1964 Corvette: Service Bulletin: Directional Signal Switch Service

Model Year: 1964 All Series Except Corvette and Comfortilt Wheel
Subject: Directional Signal Switch Service
Source: Chevrolet - Central Office - Technical Service Bulletin
Bulletin No: DR #693, Section XII
Date: September 8, 1964

1964 CHEVELLE ONLY

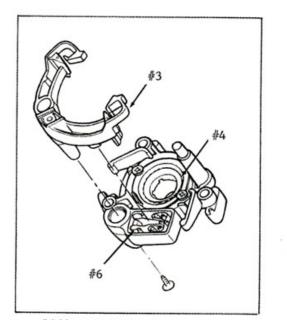
A new design, all plastic directional signal switch assembly has been used since the start of 1964 production in subject vehicles. Two versions of the basic switch design cover all the various vehicle applications.

Both version of the new switch design may be serviced with individual parts as outlined in this bulletin. This will permit component parts replacement in many cases that previously required replacement of the complete switch.

Any of the following components may be replaced without complete switch replacement; cancelling cam, actuating plate, upper mast jacket bearing and contactor kit.

ALL 1964 EXCEPT CHEVELLE

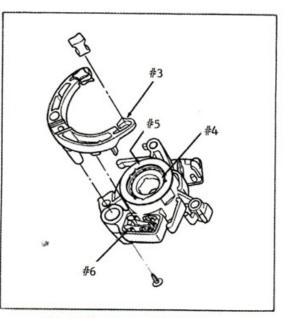
- Diagnose the problem as one that involves the directional signal switch, and eliminate other possible causes before removing the steering wheel (See attached "Trouble Shooting" guide).
- 2. Disconnect battery and remove the steering wheel per Shop Manual Instructions. On Chevelle Models, remove the retainer, spring and cancelling cam.
- 3. Remove the directional signal operating lever.
- 4. Remove the three (3) switch retaining screws and lift the switch enough to disengage the shifter tube housing.
- 5. Follow shop manual procedures of disassembly until the switch harness can be pulled out far enough to gain access to the actuating plate screw and remove the screw and actuating plate.
